| Date     | Description                          | Initials |
|----------|--------------------------------------|----------|
| 09/19/11 | REVISED SHEETS                       | DPW      |

Right of Way Plans

| Project Location: IDAHO SPRINGS DRAINAGE PHASE II |                 |              |           |

## RIGHT OF WAY PLANS OF PROPOSED COLORADO PROJECT NO. NH 0703-349 STATE HIGHWAY NO. 70 \ US 40 CLEAR CREEK COUNTY

| Project Code: 17219                               | Last Mod. Date: 09-19-2011 | Subset: 7.01 to 7.14 | Sheet No.: 7.12 |

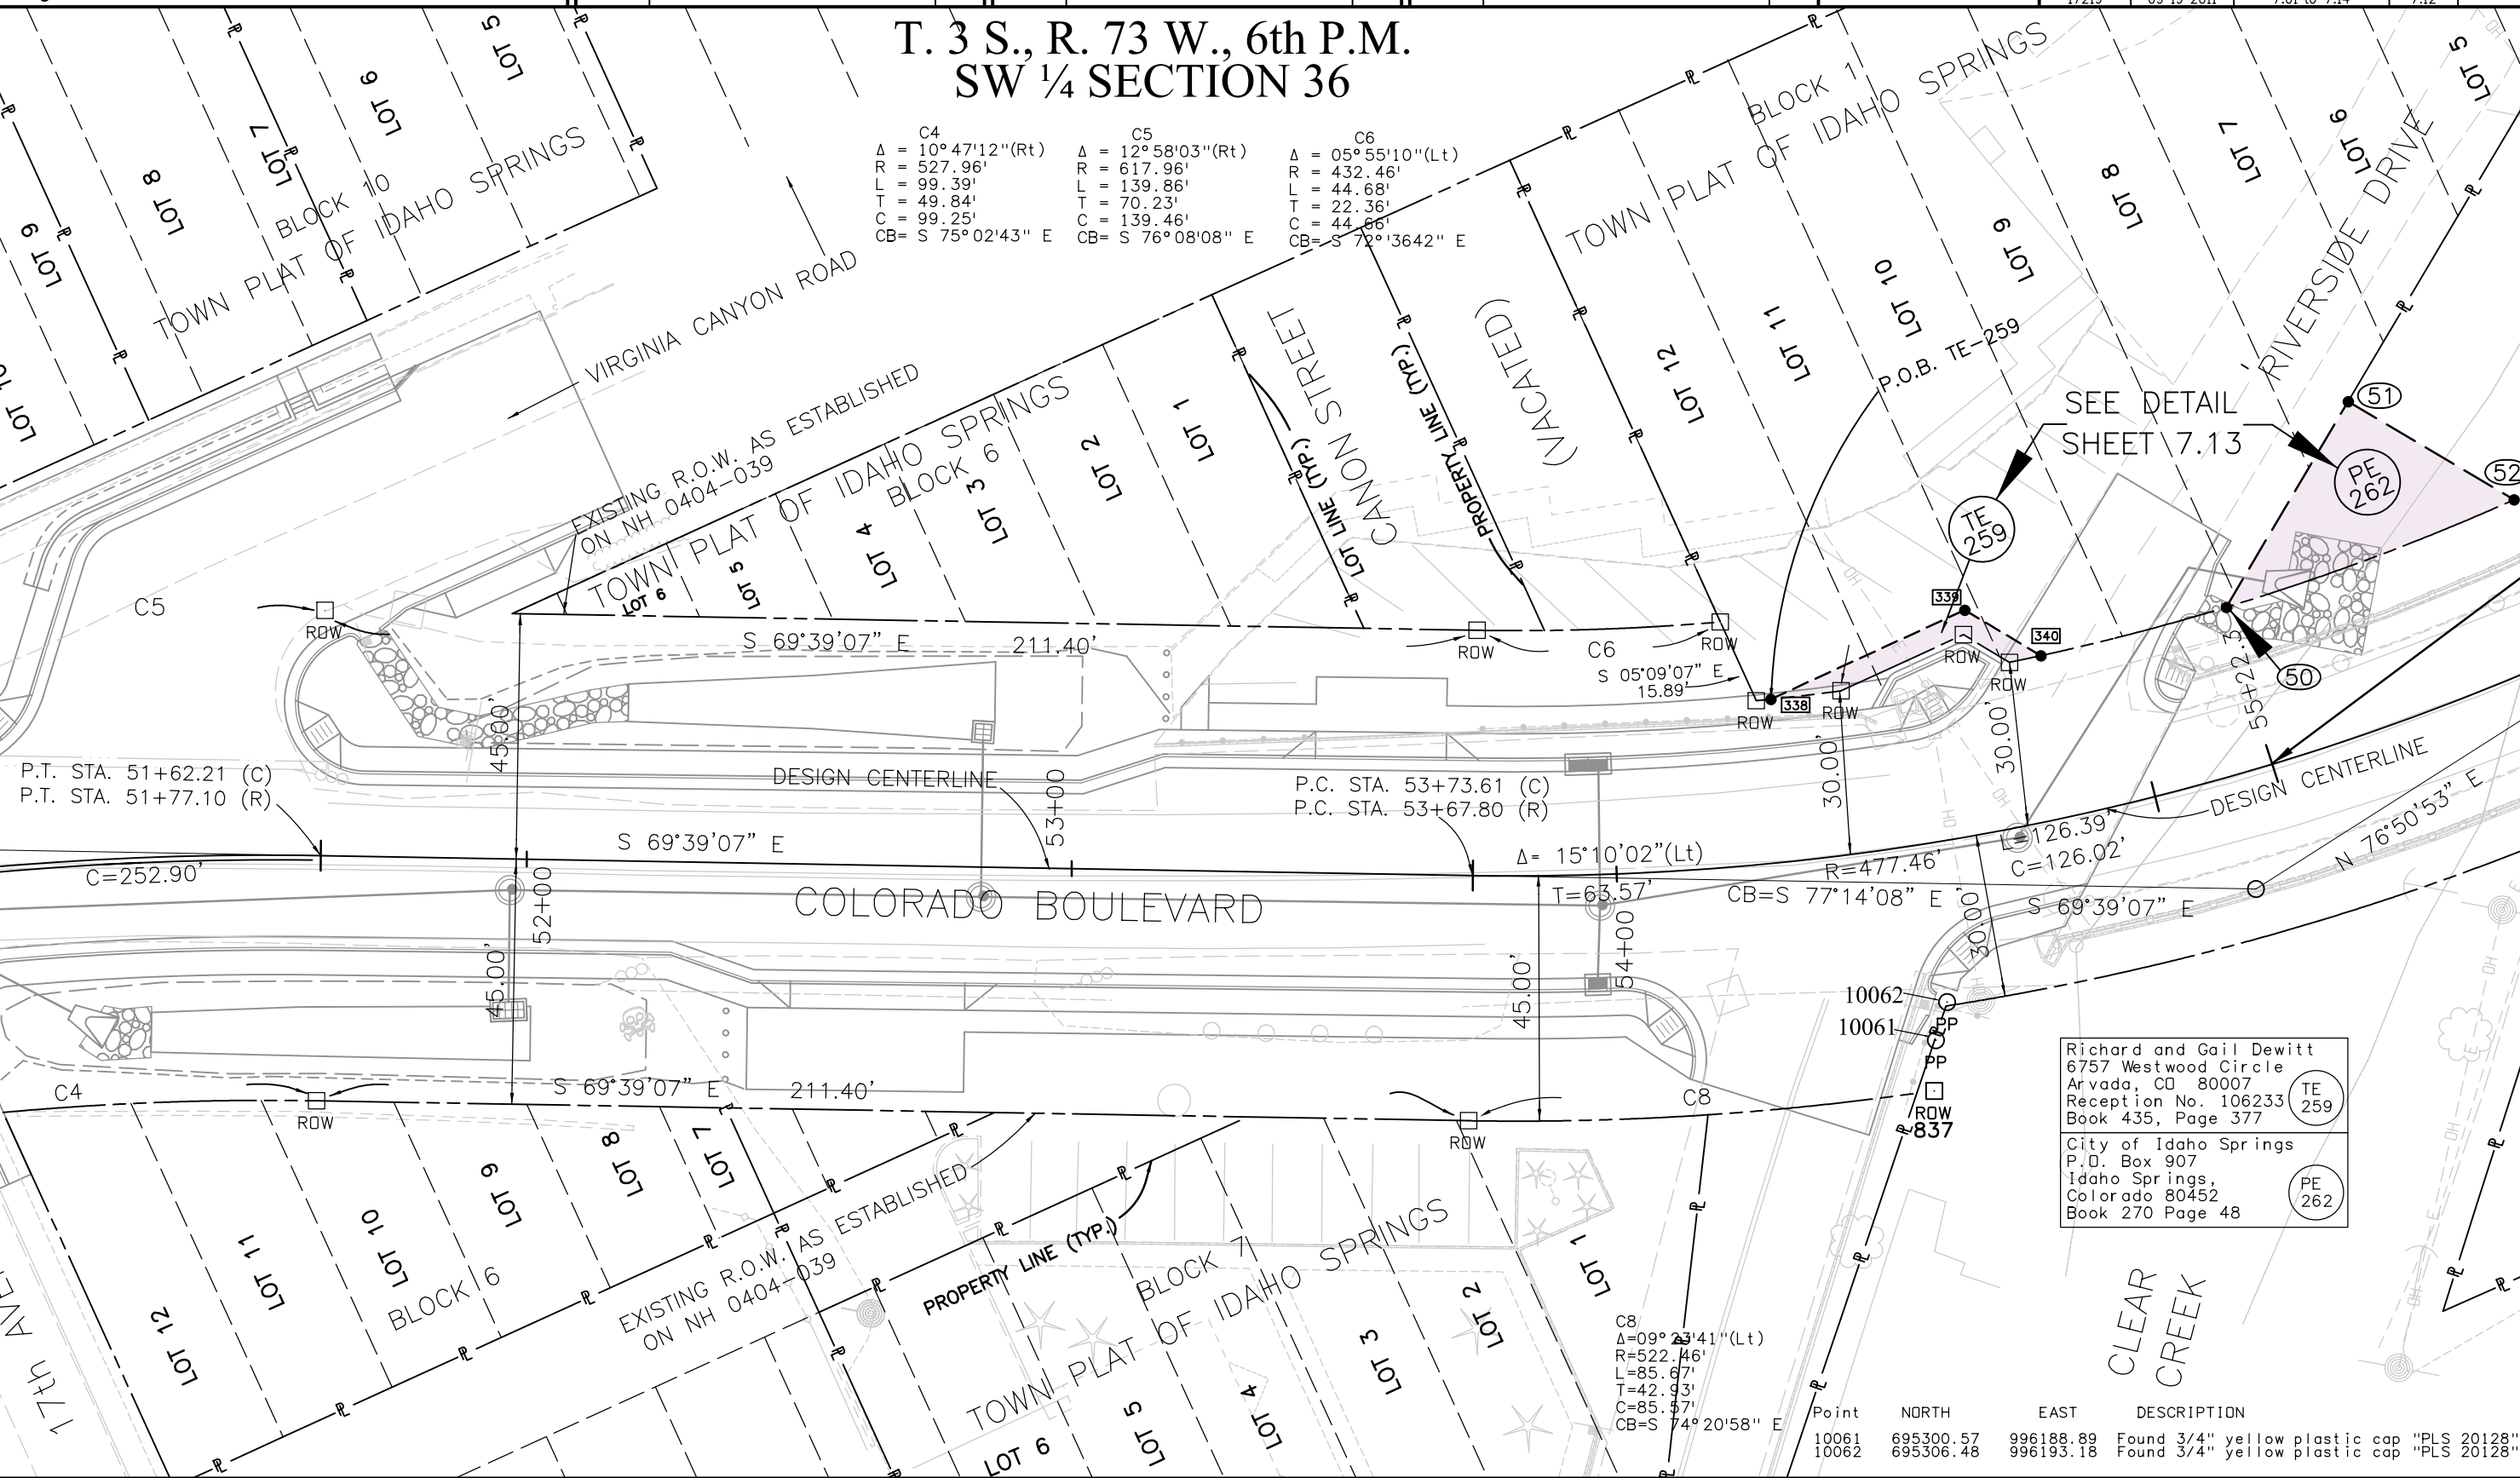
| Date     | Description       | Initials |
|----------|-------------------|----------|
| 09/19/11 | DELETE PARCEL 261 | DPW      |
| 09/19/11 | ADD PE-262        | DPW      |

| Project Code: 17219                               | Last Mod. Date: 09-19-2011 | Subset: 7.01 to 7.14 | Sheet No.: 7.13 |

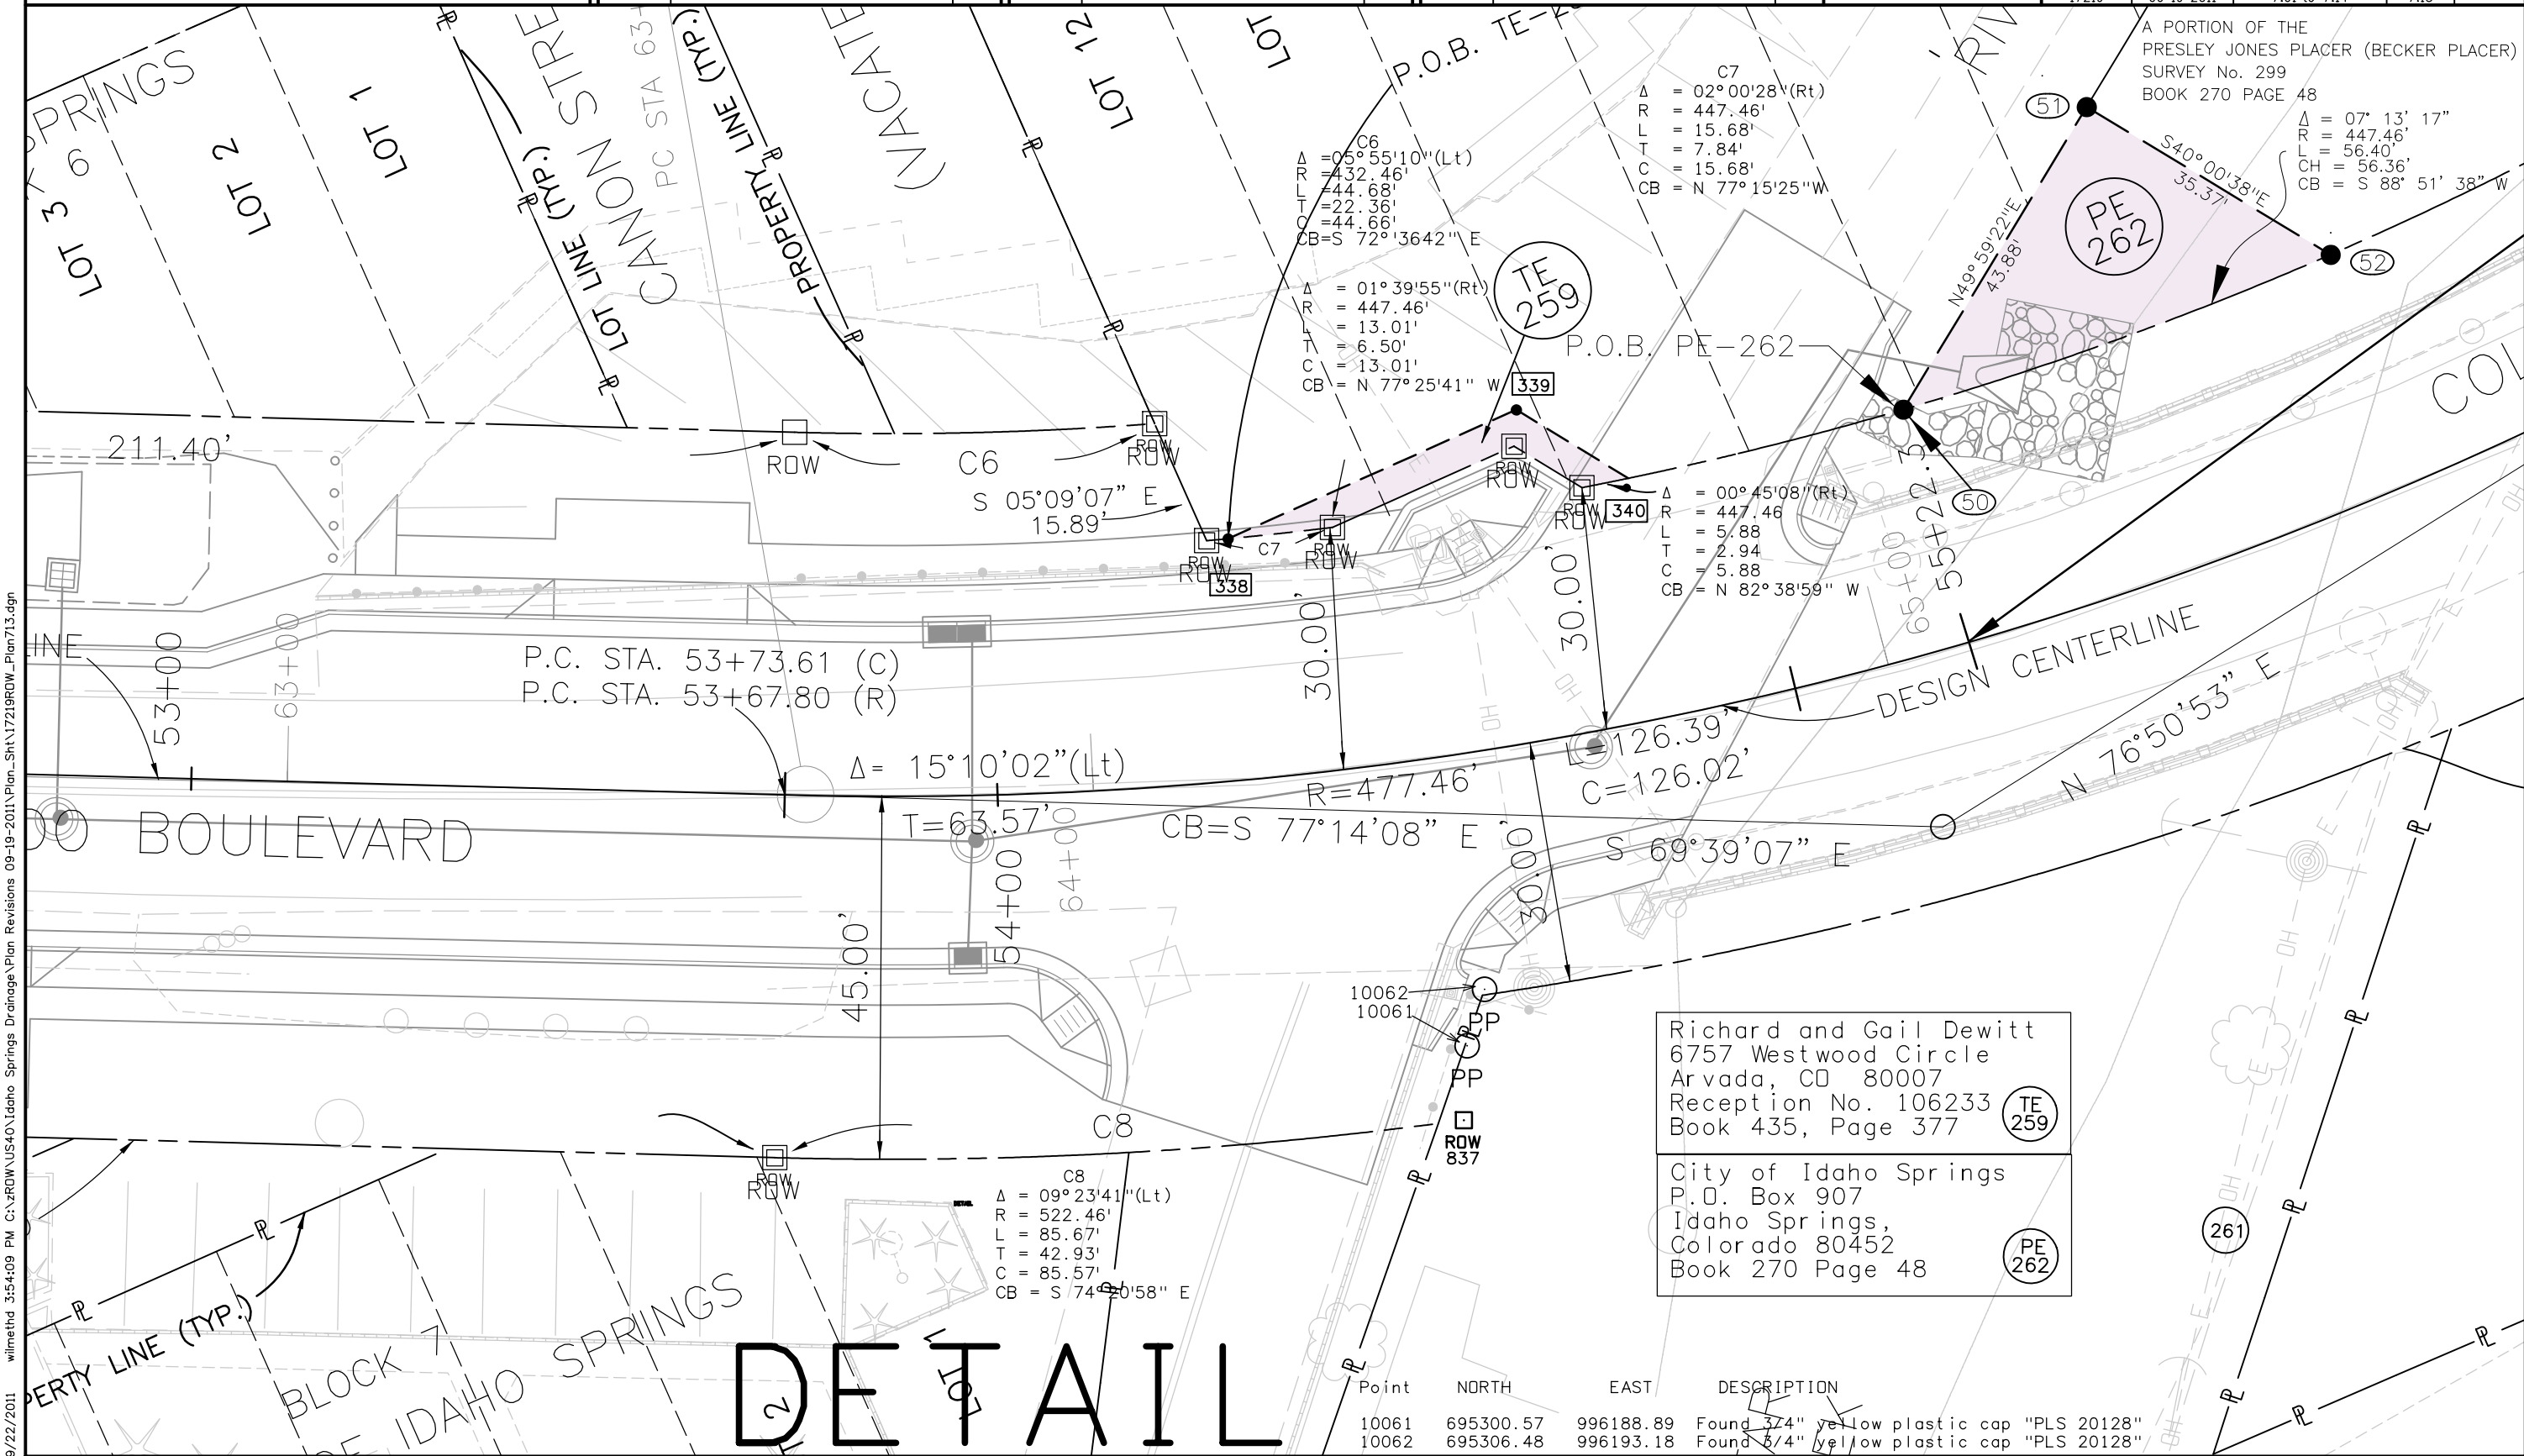
| Date     | Description       | Initials |
|----------|-------------------|----------|
| 09/19/11 | DELETE PARCEL 261 | DPW      |
| 09/19/11 | ADD PE-262        | DPW      |

PE  
262

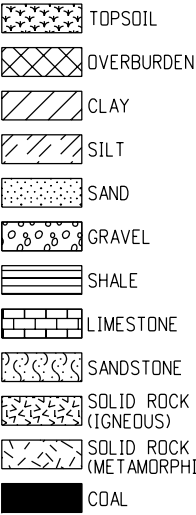
| Date     | Description       | Initials |
|----------|-------------------|----------|
| 09/19/11 | DELETE PARCEL 261 | DPW      |
| 09/19/11 | ADD PE-262        | DPW      |
